**DRAFT MEETING
 NOTES & CONCEPTS
 FROM WORKSHOP #2**
 POSTED 5-10-2019
 REVISED 6-27-2019

Submitted by: **Mark A Kosmos, Landscape Architect**
 mkosmos@eugene-or.gov
 Project website: **www.eugene-or.gov/strikerfield**

Striker Field Park

Park Access, Transportation & Planning

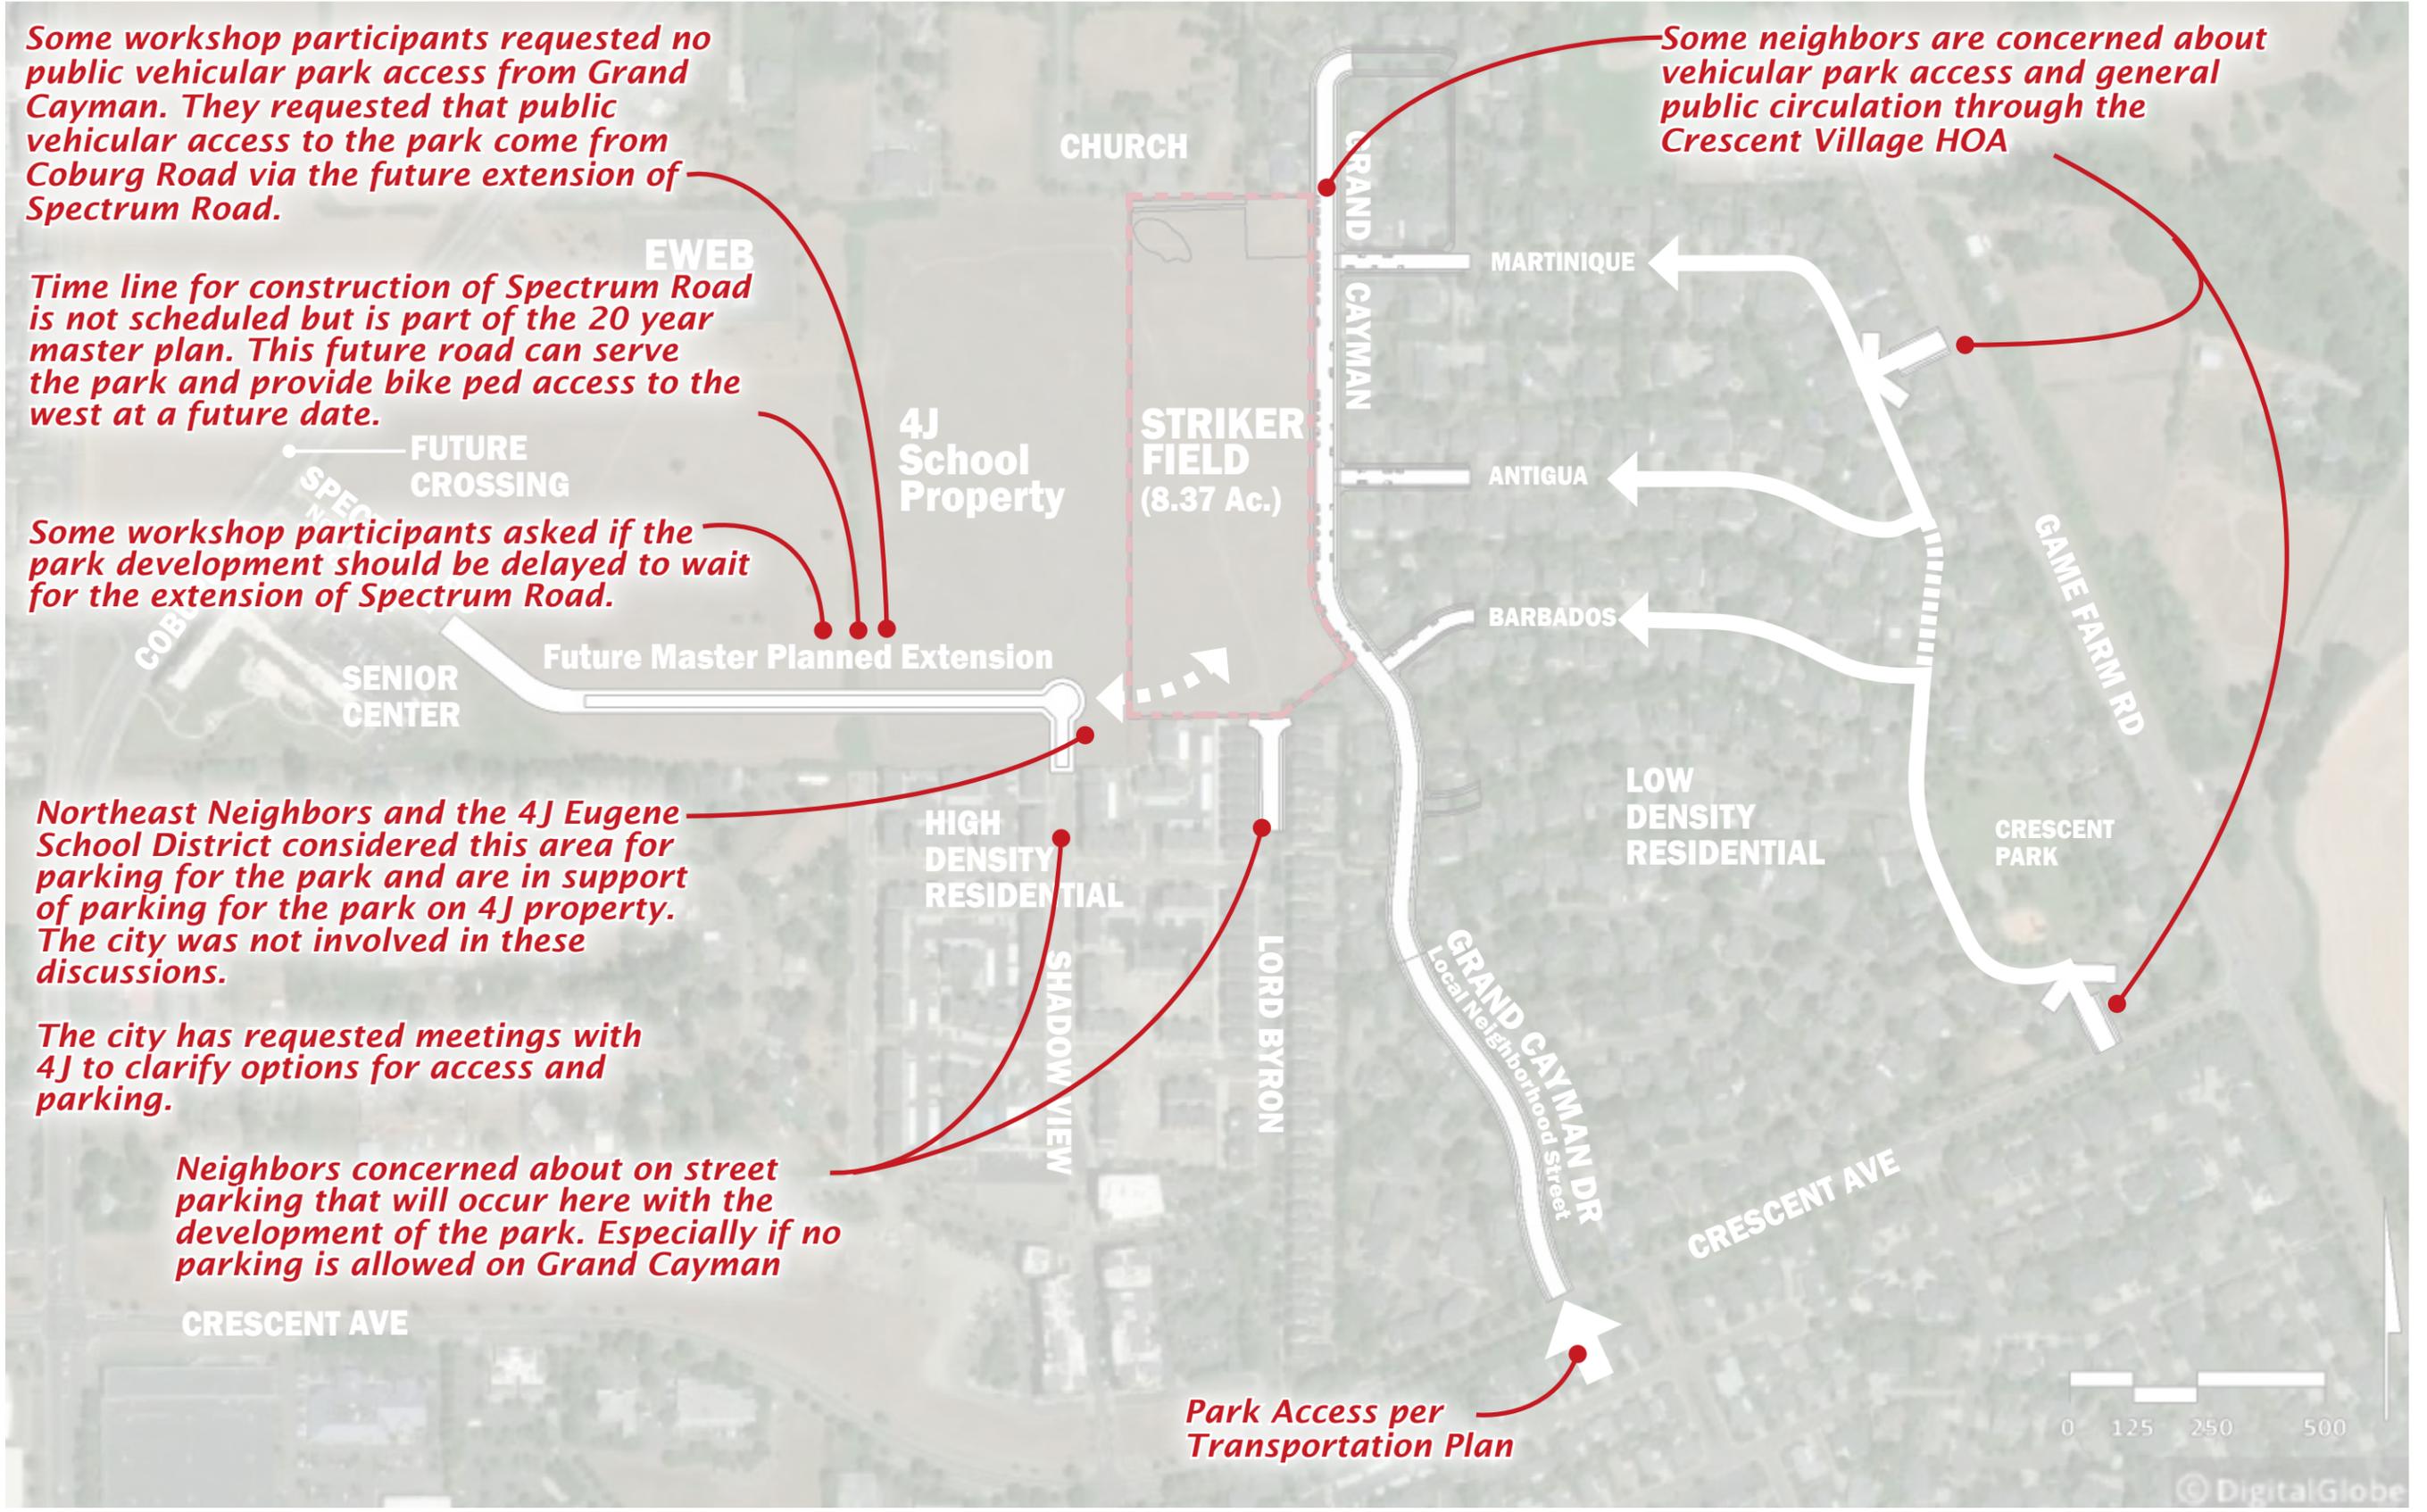
Some workshop participants requested no public vehicular park access from Grand Cayman. They requested that public vehicular access to the park come from Coburg Road via the future extension of Spectrum Road.

Some workshop participants asked if the park development should be delayed to wait for the extension of Spectrum Road.

Northeast Neighbors and the 4J Eugene School District considered this area for parking for the park and are in support of parking for the park on 4J property. The city was not involved in these discussions.

Neighbors concerned about on street parking that will occur here with the development of the park. Especially if no parking is allowed on Grand Cayman

Some neighbors are concerned about vehicular park access and general public circulation through the Crescent Village HOA

Time line for construction of Spectrum Road is not scheduled but is part of the 20 year master plan. This future road can serve the park and provide bike ped access to the west at a future date.

The city has requested meetings with 4J to clarify options for access and parking.

Concept Options - Organization of Major Elements

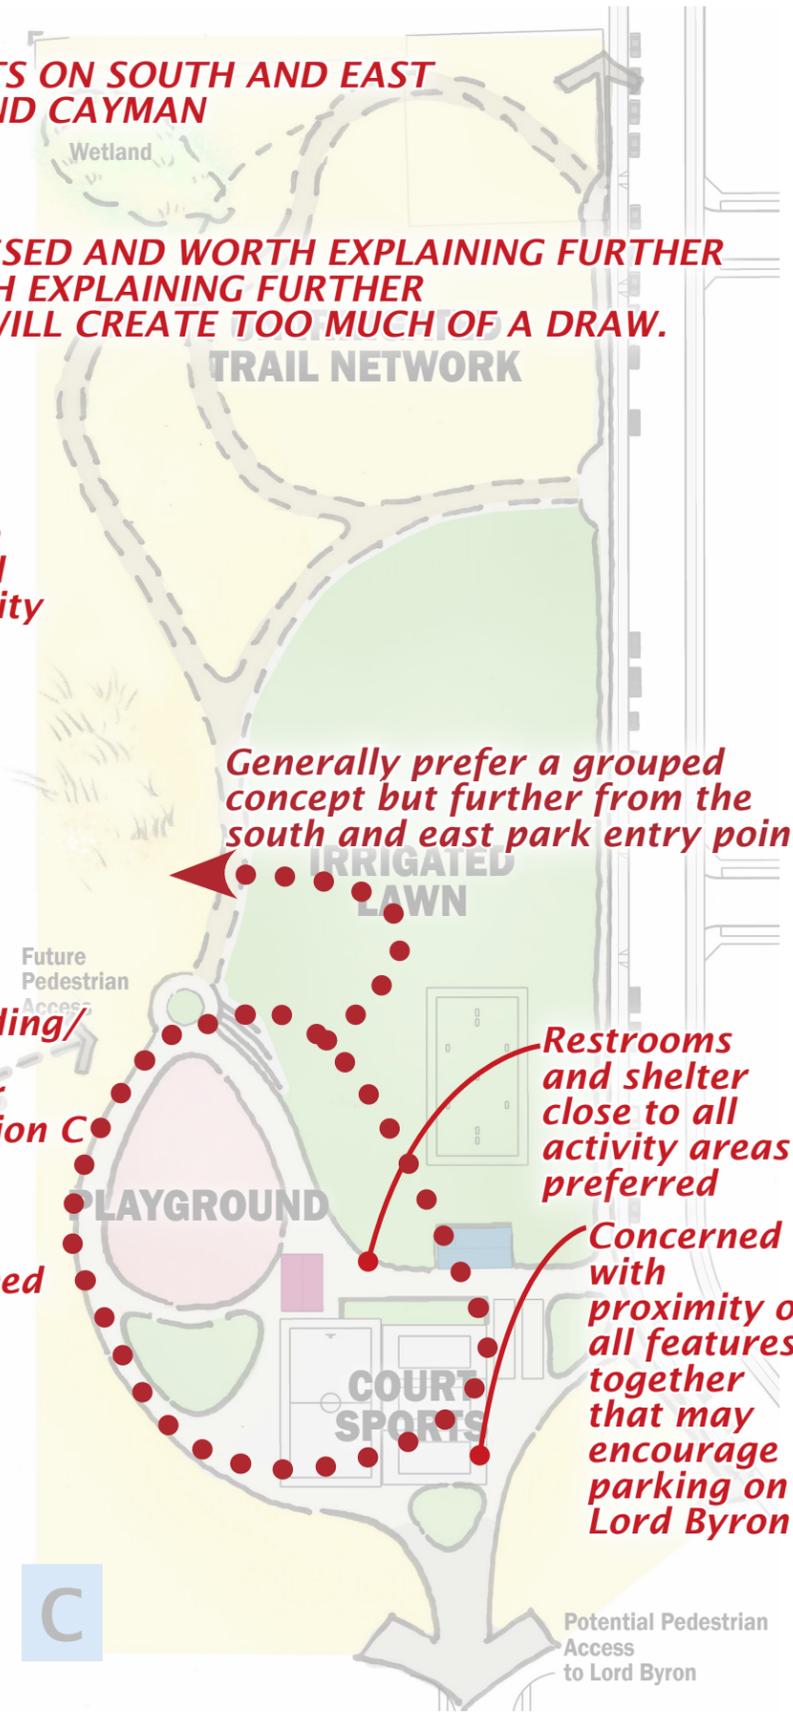
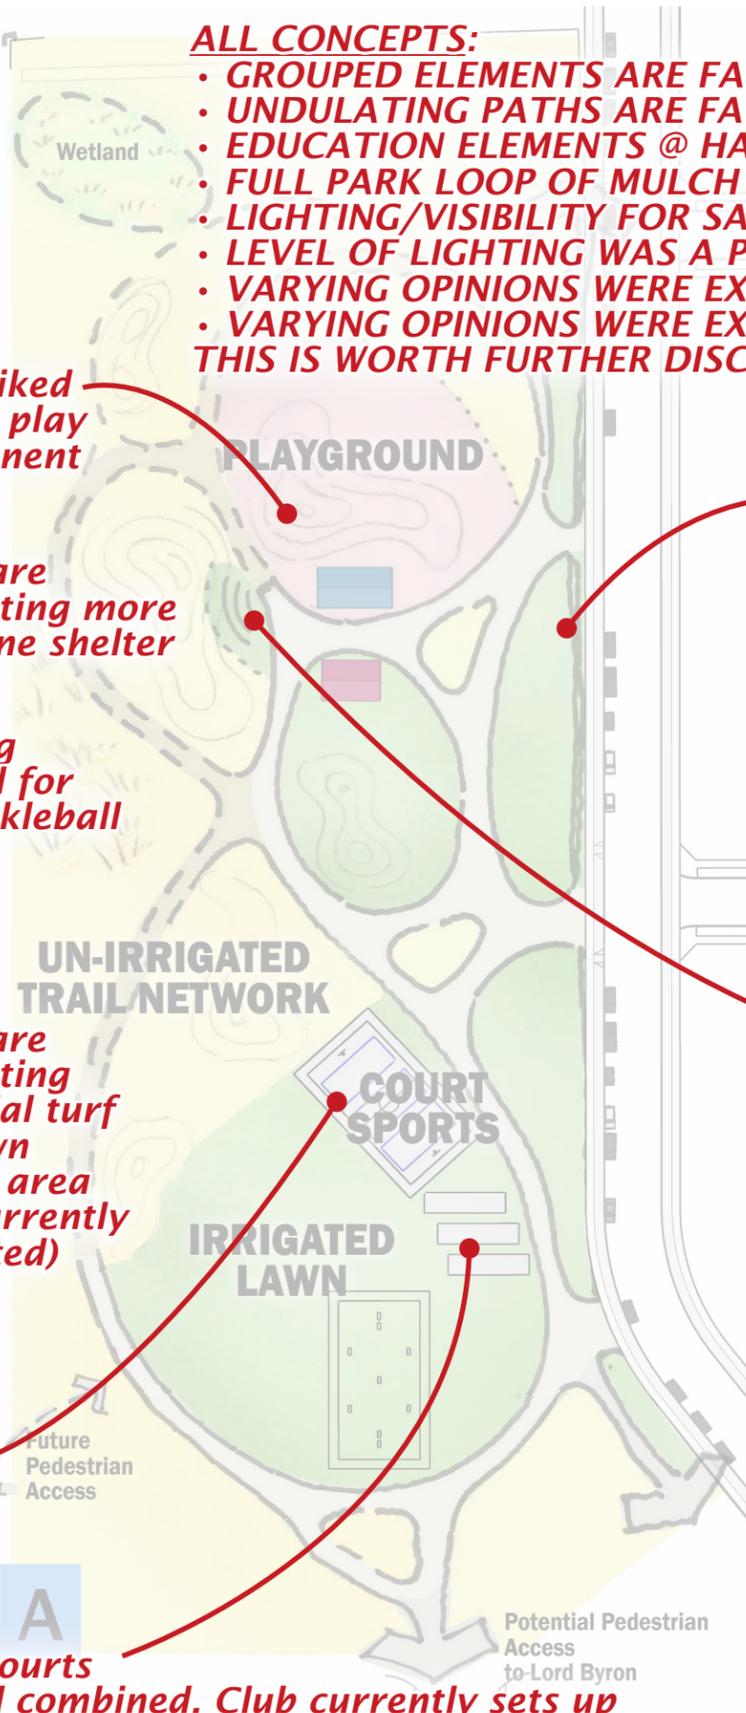
Some people liked the sculptural play mound component in this option

Some are requesting more than one shelter

Fencing needed for the pickleball courts

Some are requesting artificial turf for lawn games area (not currently budgeted)

Shared use courts not preferred

Petanque courts better if all combined. Club currently sets up 8 courts @50x100 on baseball infield

Generally, curvilinear paths are preferred on all concepts including the walk along Grand Cayman

Options with concrete loop are preferred for accessibility

Generally prefer a grouped concept but further from the south and east park entry points

Prefer mounding/berm for amphitheater space vs. option C

This should not interrupt future bike/ped connection

Restrooms and shelter close to all activity areas is preferred

Concerned with proximity of all features together that may encourage parking on Lord Byron
